ADDENDUM #1

Reference: Group Use Area New Restroom - Starvation State Park
Division of Parks and Recreation
DFCM Project No. 06156510

ADDENDUM NO. 1

Division of Parks and Recreation
Starvation State Park New Restroom
DFCM Project No. 06156510

CRACK CONTROL JOINT TYPICAL @ CMU WALLS

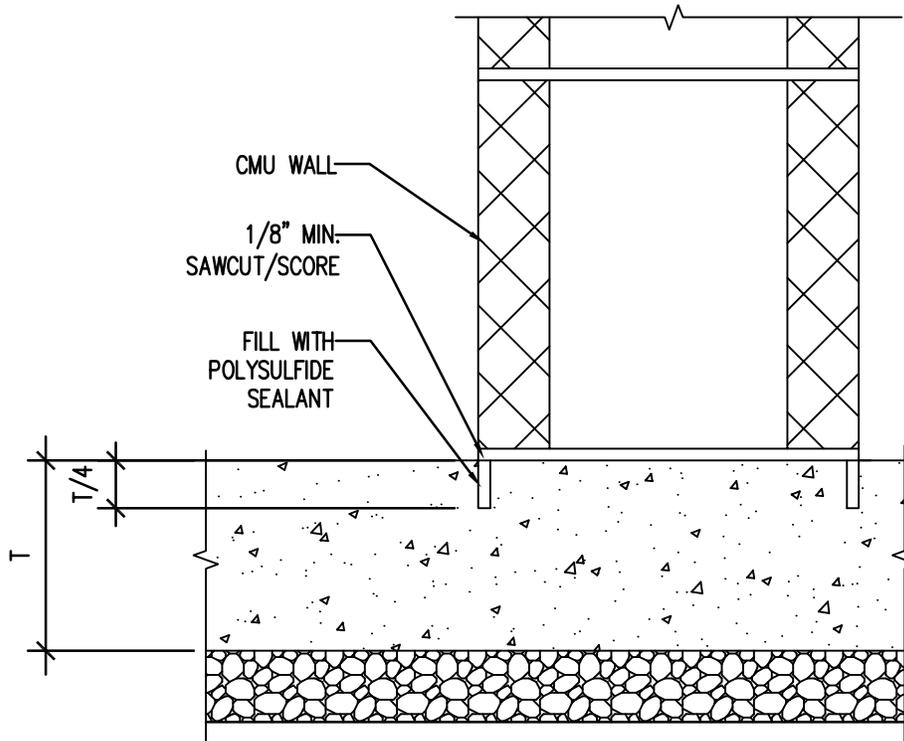
1. See attached 8 ½" x 11" addendum drawing 01/AD-01. Drawing indicates that the general contractor will be required to saw cut concrete slab at all interior block wall location as shown on attached addendum drawing and provide polysulfide sealant at all interior saw cut locations.
2. Metal toilet partitions and urinal dividers are included in the scope of work. See architectural drawings and specification section 10155

POLYSULFIDE JOINT SEALANT SCHEDULE:

PRODUCTS: PROVIDE PRODUCT THAT COMPLYING WITH THE FOLLOWING.

- a. TWO-PART SEALANT, SONNEBORN BUILDING PRODUCTS.
- b. T2282; MORTON INTERNATIONAL, INC.
- c. cm-60; W.R. MEADOWS, INC.

CLASS AND GRADE: M(MULTICOMPONENT) AND NS (NONSAG)

CLASS: 25

USES RELATED TO JOINT SUBSTRATE; M,G AND A

USES RELATED EXPOSURE; T AND NT
